Your Ref: PP_2018_HAWKE_002_02
Our Ref: LEP005/14

Review of Altered Gateway Determination at 2 Inverary Drive, Kurmond

Reference is made to your correspondence received 18 January 2021 seeking Council's comments in relation to a request for the Department of Planning, Industry and Environment to review the Altered Gateway Determination dated 3 December 2020 for Planning Proposal LEP005/14 at 2 Inverary Drive, Kurmond.

Figure 1: Mapped Significant Vegetation on the Subject Site

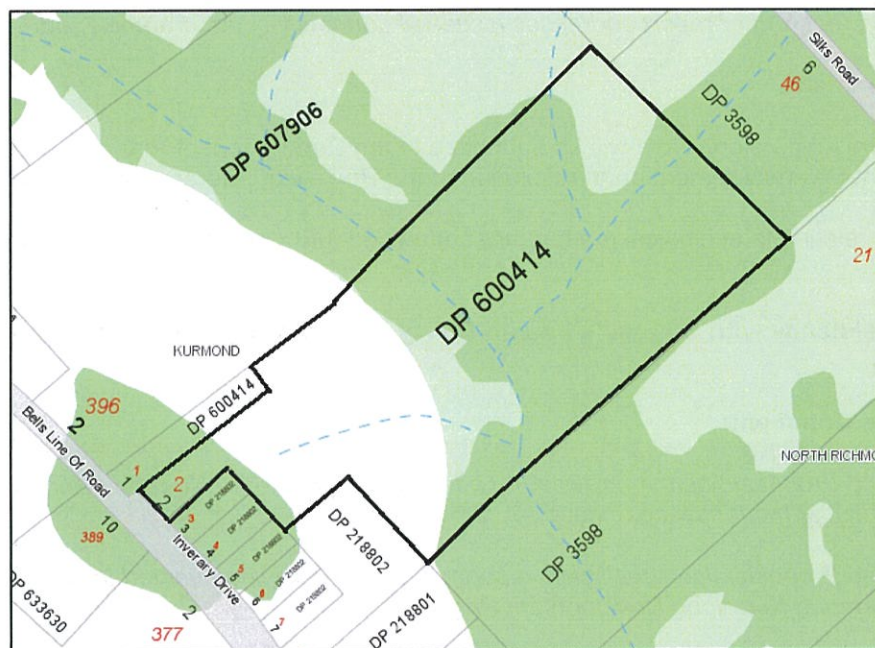
Areas within the subject site are mapped as 'Significant Vegetation' under the *Hawkesbury Local Environmental Plan 2012*, and as a result the requirements of Clause 6.4 – *Terrestrial biodiversity* will apply to the future development of the land. Figure 1 shows the areas of the subject site which contain 'Significant Vegetation' under the *Hawkesbury Local Environmental Plan 2012*.

In this respect it should be noted that through public agency consultation, NSW Environment, Energy and Science provided a response to Council detailing issues with the Flora and Fauna Assessment Report prepared by Envirotech that had been prepared to support the Planning Proposal. A copy of that response is attached, but highlights NSW Environment, Energy and Science views that the Flora and Fauna Assessment Report is inadequate and invalid and the condition of the vegetation on site has been underestimated.

Figure 2: Slope Analysis of the Subject Site

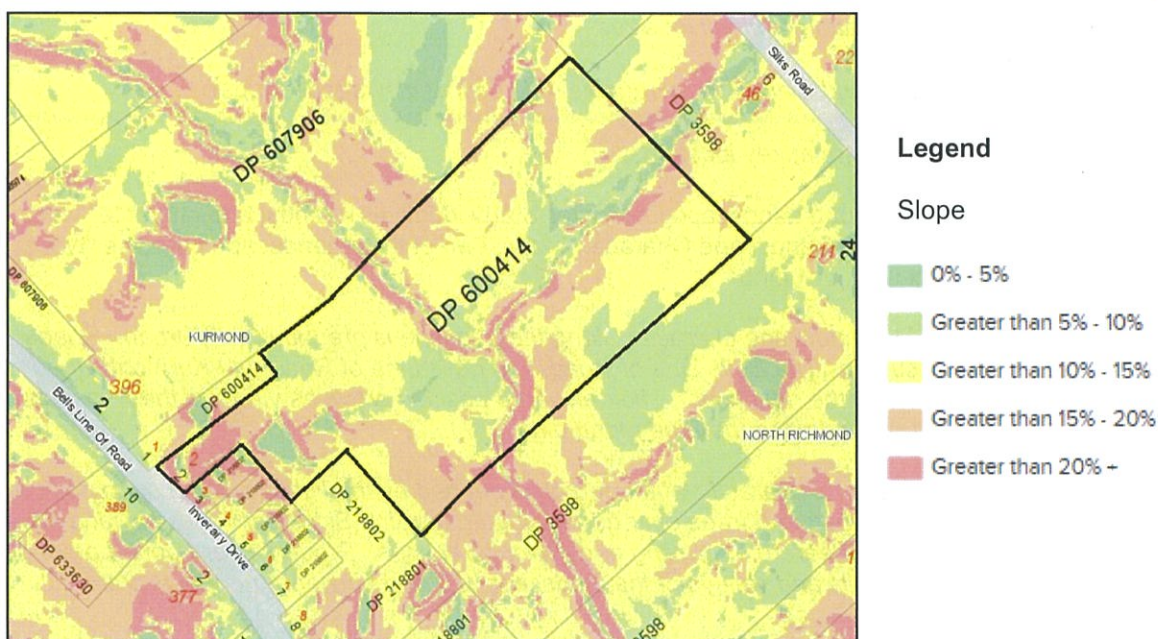
The land varies in height from approximately 90m AHD at the Inverary Drive road frontage to approximately 60m AHD at the watercourse which runs north-west to south-east through the centre of the subject site. From this watercourse the land rises to a level of approximately 80m AHD at the rear of the subject site. Based on Council's slope mapping, the subject site contains some land having slopes in excess of 15%, particularly around the watercourses, and at the front of the property. Figure 2 below provides a slope analysis of the subject site.

The Planning Proposal has not currently demonstrated that future development will:

- enable all building envelopes, asset protection zones (APZs), driveways and roads to be located on land with a slope of less than 15%;
- avoid the removal of significant vegetation, or minimise the fragmentation of significant vegetation. This matter is discussed in Point 3 below, and the response from NSW Environment, Energy and Science is highlighted above (and attached).

Figure 3: Portion of subject site within ‘ridgeline street’ and ‘pastoral valley’ character type

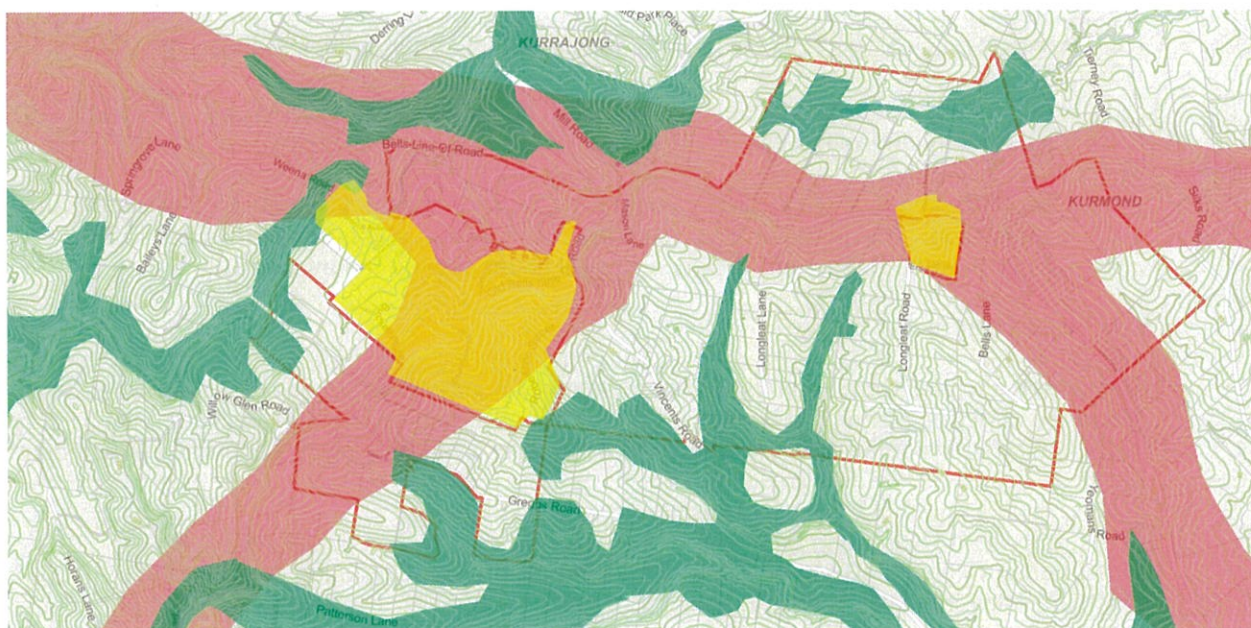
Figure 3 below shows the areas on the subject site identified as 'ridgeline streets' and 'pastoral valleys'.

The Kurmond and Kurrabung Landscape Character Study identifies that “*the pastoral character contributes to the scenic qualities of the area by virtue of the lack of buildings.*”

Figure 4: Biodiversity Priority Ranking

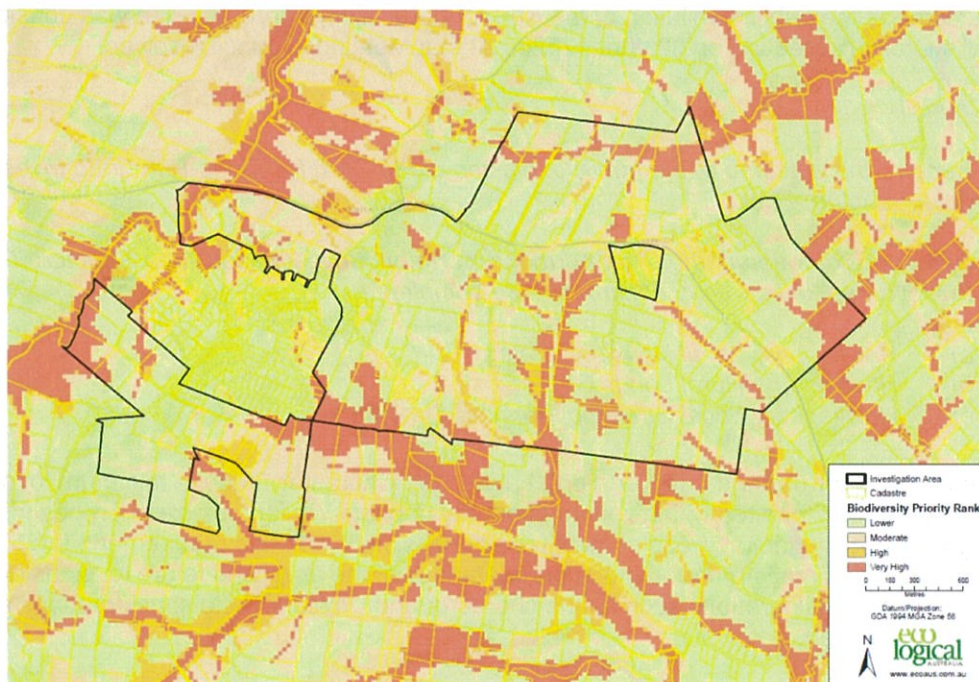
The ranking of very high priority habitat, which corresponds to the areas around the existing watercourses, reinforces the significance of the vegetation as identified under the *Hawkesbury Local Environmental Plan 2012*. Reference is also made to the NSW Environment, Energy and Science response and comments on the matter.

As identified in the Kurmond and Kurrabung Landscape Character Study, a minimum lot size of 5,000m² is required for sites within very high priority habitat. The subdivision layout plan shows proposed lots within the very high priority habitat area as having sizes ranging from approximately 2,000m² to 3,000m², which is inconsistent with the Study recommendations.

Figure 5: Minimum Lot Sizes for Subdivision under Draft Kurmond Kurrajong Structure Plan (Green – 4,000m²; White – 1 ha)

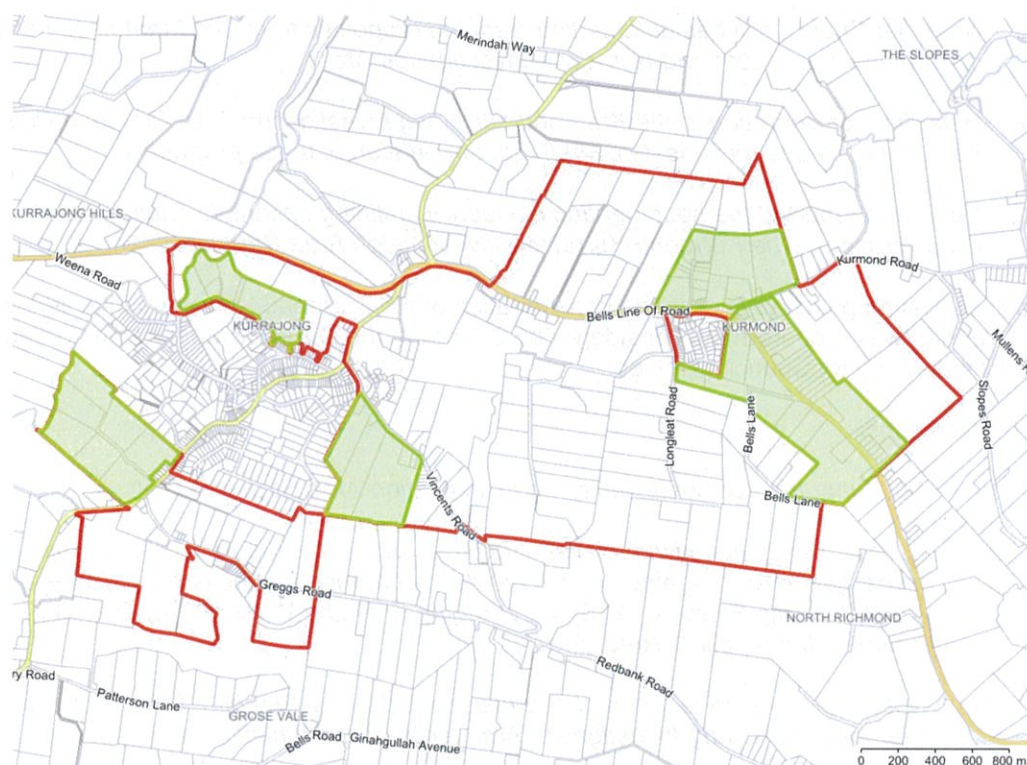
In relation to the subject site, the Structure Plan nominates a minimum lot size for subdivision of 4,000m² at the front of the subject site, and 1 hectare at the rear of the property to maintain the pastoral character of the locality. Figure 5 below shows the area nominated as a 4,000m² minimum lot size for subdivision coloured green within the Draft Structure Plan.

The Planning Proposal seeks to create allotments with a minimum size of 2,000m² and is therefore inconsistent with the minimum lot sizes for subdivision proposed by the Draft Kurmond Kurrajong Structure Plan.

Figure 6: Watercourse Locations and Riparian Corridor Width

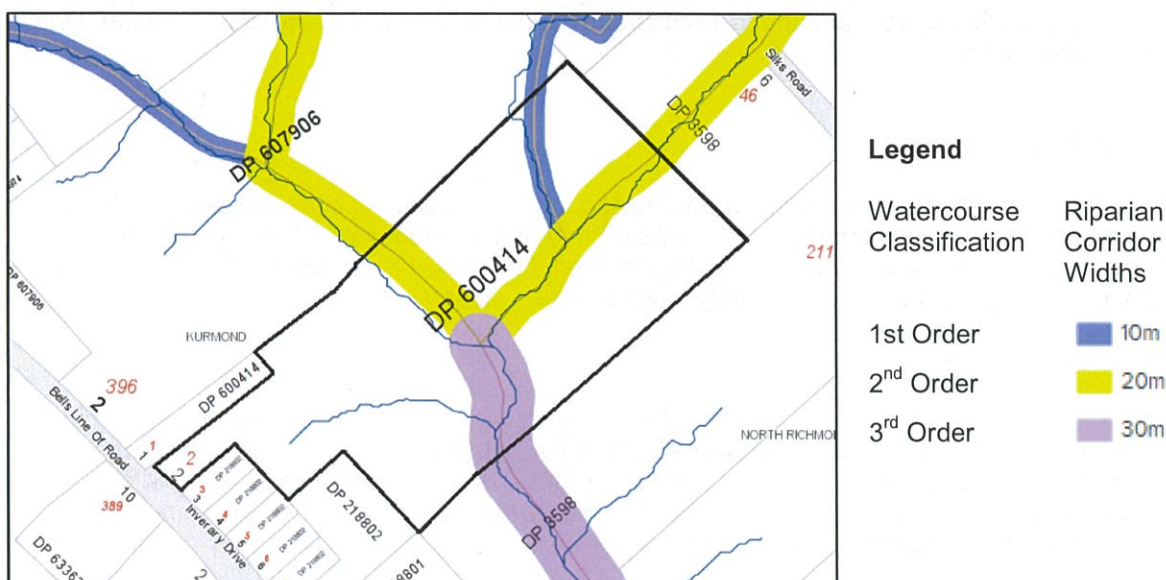
A number of watercourses traverse the subject site. Figure 6 below, extracted from Council's records, shows the location of these watercourses, the Strahler classification of the watercourses and corresponding widths of their riparian corridors.

The Ecological Assessment Report, in Section 8.2.5, further states that riparian corridors should be maintained for watercourses on site that constitute 2nd and 3rd order streams. Therefore the 2nd

order watercourse connecting from the rear of the site to the main watercourse dissecting the property should be allocated a riparian corridor of 20m on each side of the watercourse. In addition, this watercourse and its riparian corridor should be contained within one lot, to better protect, conserve and rehabilitate the riparian areas and the biodiversity it supports. The Planning Proposal does not recognise this watercourse and riparian area, and as such it is located to the rear of a number of lots. Buffer planting is proposed in this location, however such landscaping is considered unsatisfactory as it does not provide for the required riparian corridor, in size, or adequate habitat.
